Rev. 11-19-41-P.B.B.-Net length of project; Str. D-13-H removed.
Rev. 1-22-46-S.H.L.-Tree Index
Rev. 5-13-47-W.H.M.-Chg. Div. and Res. Eng.

COLORADO STATE HIGHWAY DEPARTMENT

PLAN AND PROFILE OF PROPOSED FEDERAL AID PROJECT NOS. 151-A(3) 151-B(2) 151-C(3) STATE HIGHWAY NO. 2 GRAND COUNTY

STATE	COUNTY	SHEET NO.	TOTAL SHEETS
IND.	CLAY	151 B	15
		F.A.R.	
		151-B(2)

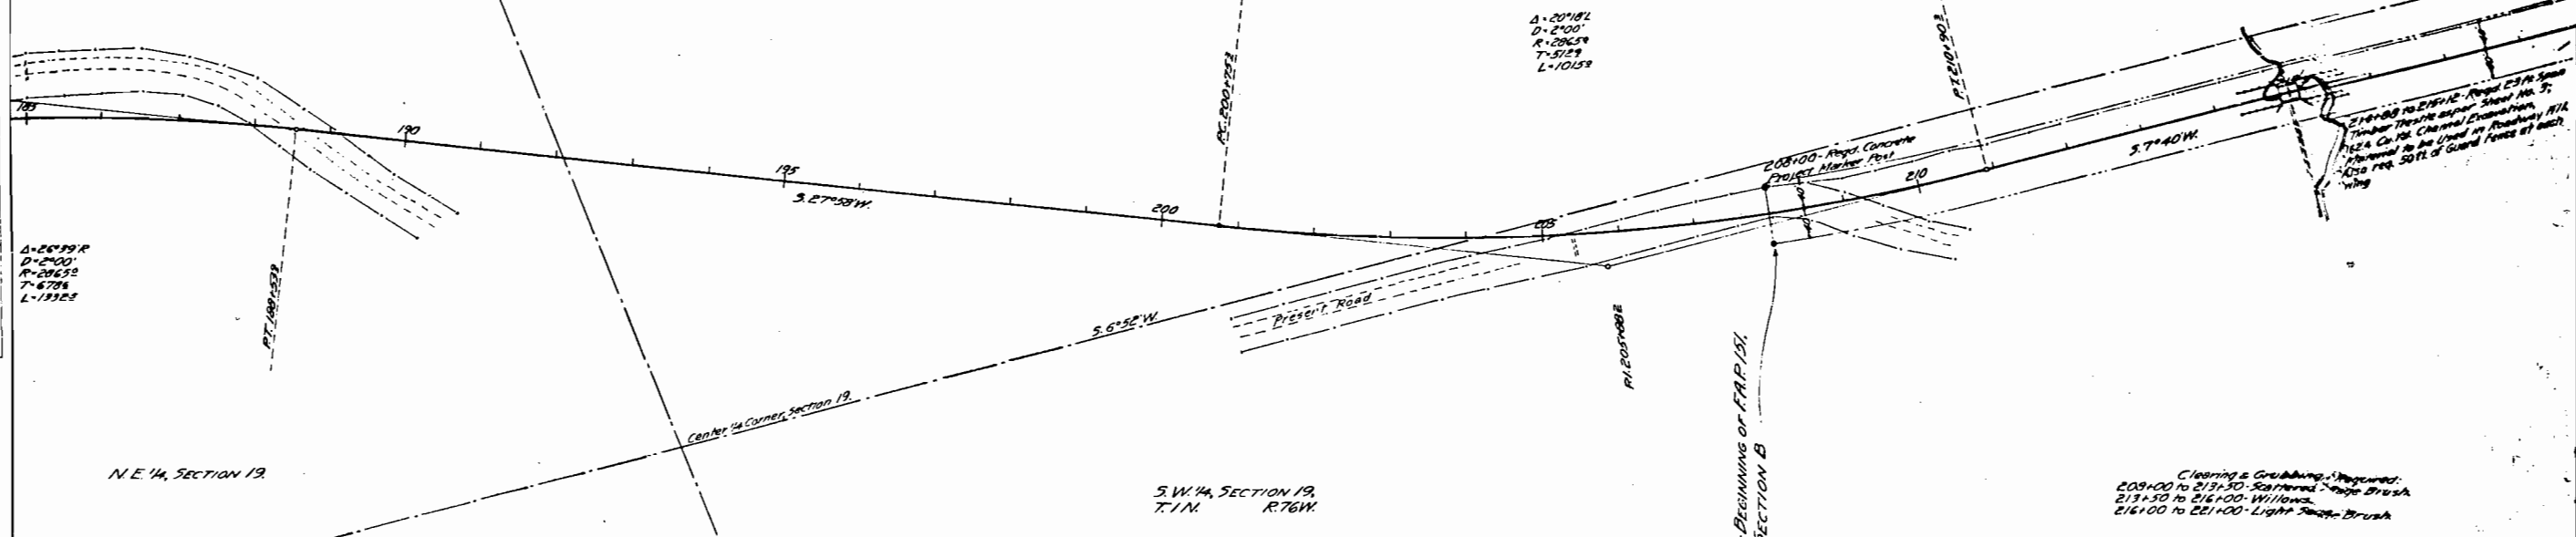
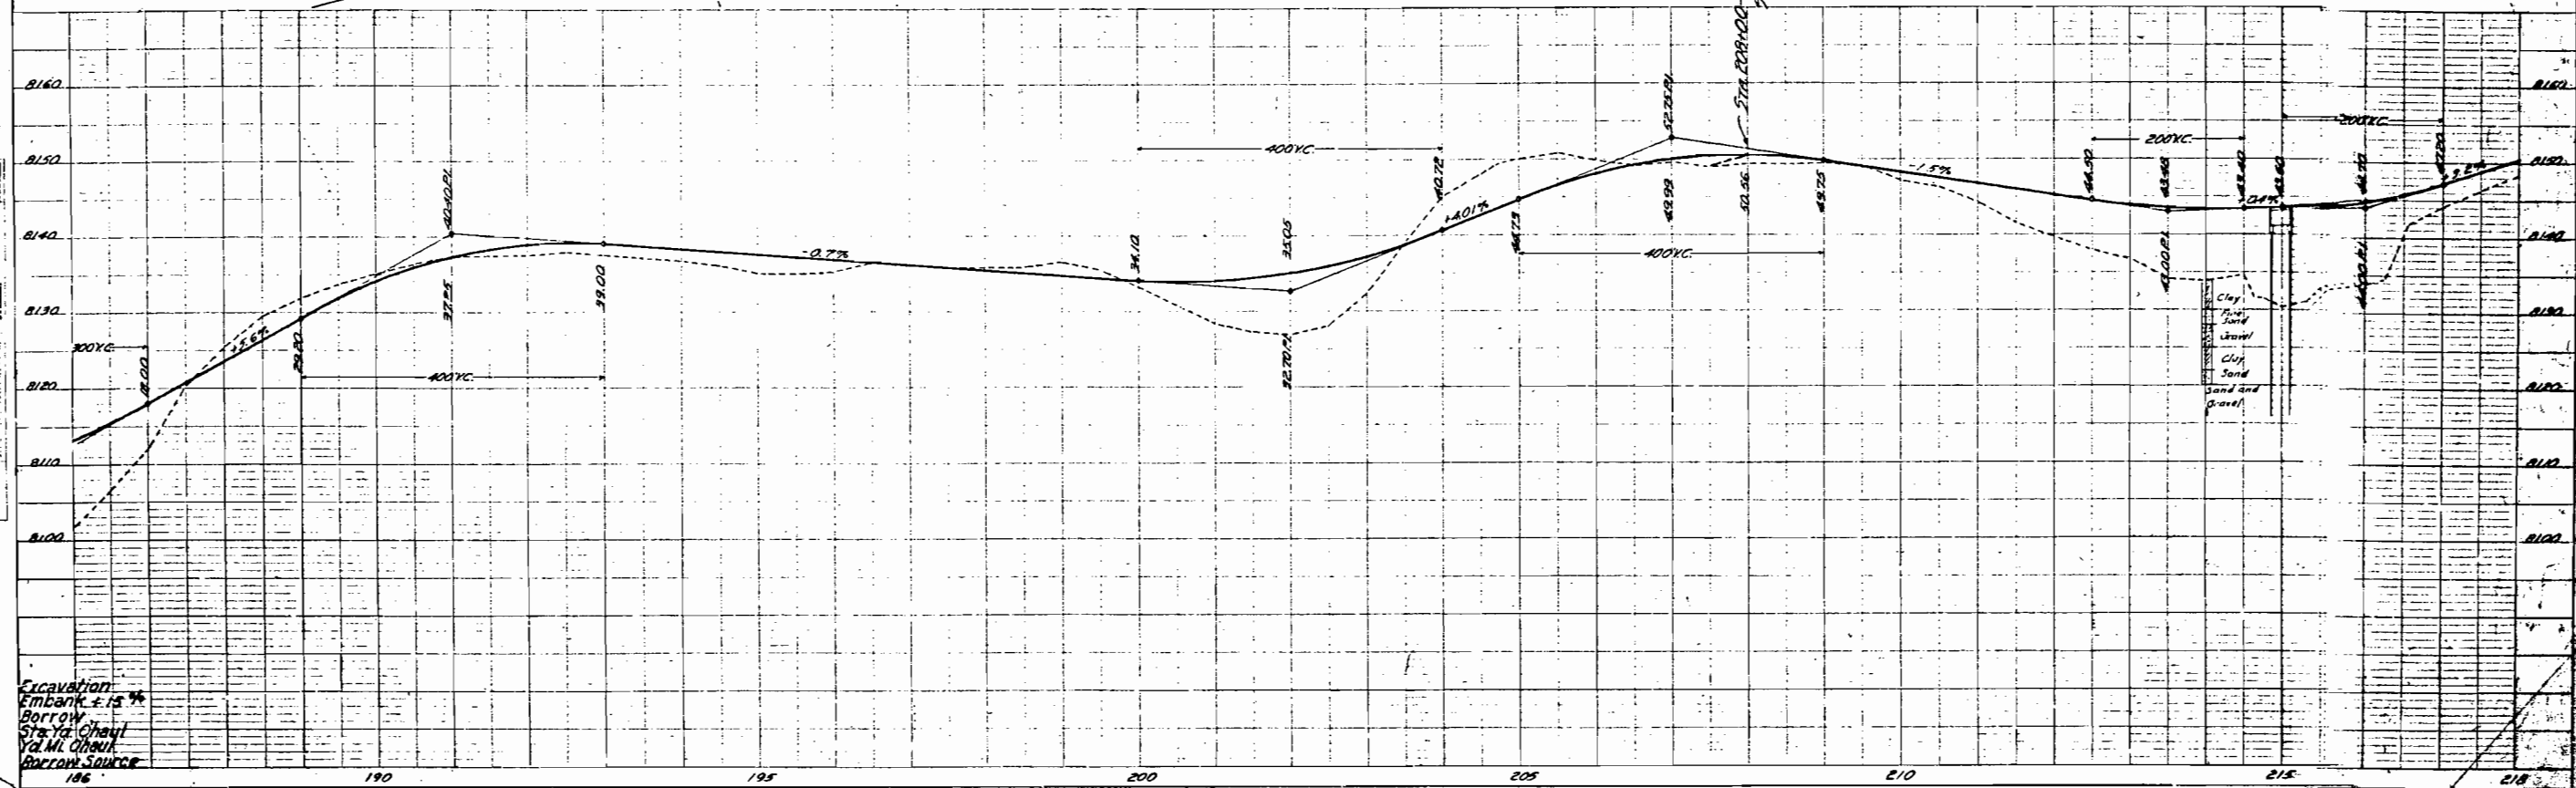
F.A.R. 151-B(2)
214+ to 215+ - Remove and
Rebuild 4-50 ft. lengths of
Wire Cable Guard Fence on
Lt. & Rt.
